**Advanced Passive 1000 (AP1000)
Generic Technical Specification Traveler (GTST)**

Title: Changes Related to LCO 3.7.12, Spent Fuel Pool Storage

Figure 3.7.12-1 (page 1 of 1)
Minimum Fuel Assembly Burnup Versus Initial Enrichment for Region 2 Spent Fuel Cells

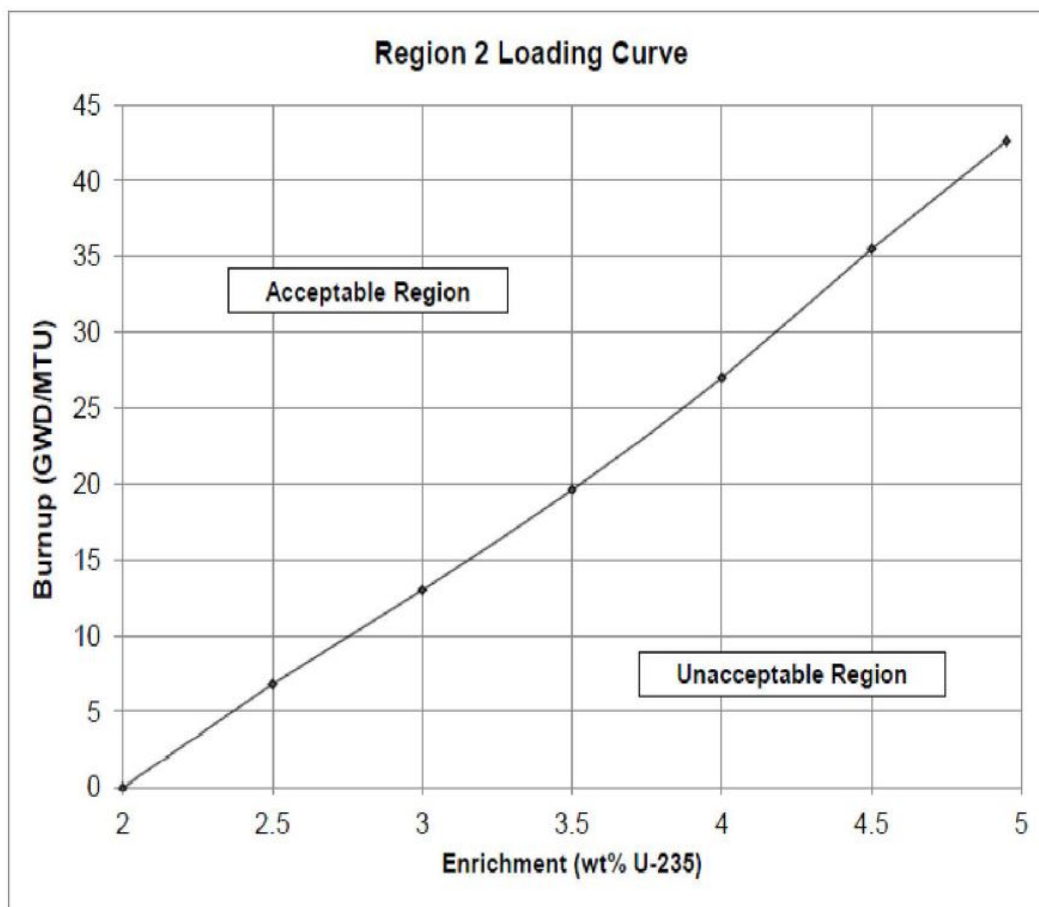
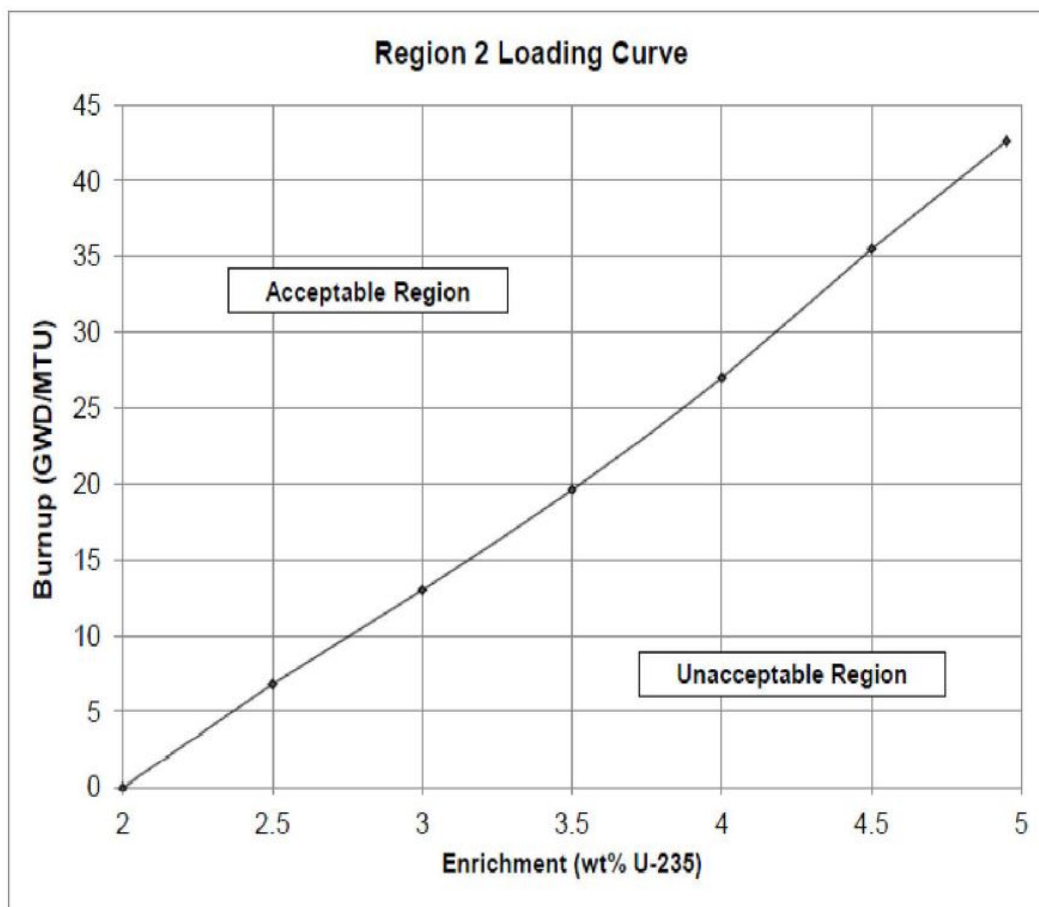
VEGP LAR DOC A003: References to various Chapters and Sections of the Final Safety Analysis Report (FSAR) are revised to include FSAR.
VEGP LAR DOC A105: Correct references to Spent Fuel Pool
VEGP LAR DOC A111: Revision of Figure 3.7.12-1
VEGP LAR DOC L05: TS LCO 3.0.8 is eliminated

GTS Figure 3.7.12-1 is revised by adding area labels to provide clarity. (DOC A111)

DOC A111 annotates the acceptable and unacceptable regions for loading on Table 3.7.12-1.

DOC A111 provides clarity in interpretation of Table 3.7.12-1.

Region 2 permits storage of spent fuel assemblies in any cell location provided the assembly meets the combination of initial enrichment and burnup shown in LCO Figure 3.7.12-1, Minimum Fuel Assembly Burnup Versus Initial Enrichment for Region 2 Spent Fuel Cells. **The Acceptable Region of the Figure is to the left and above the curve.**
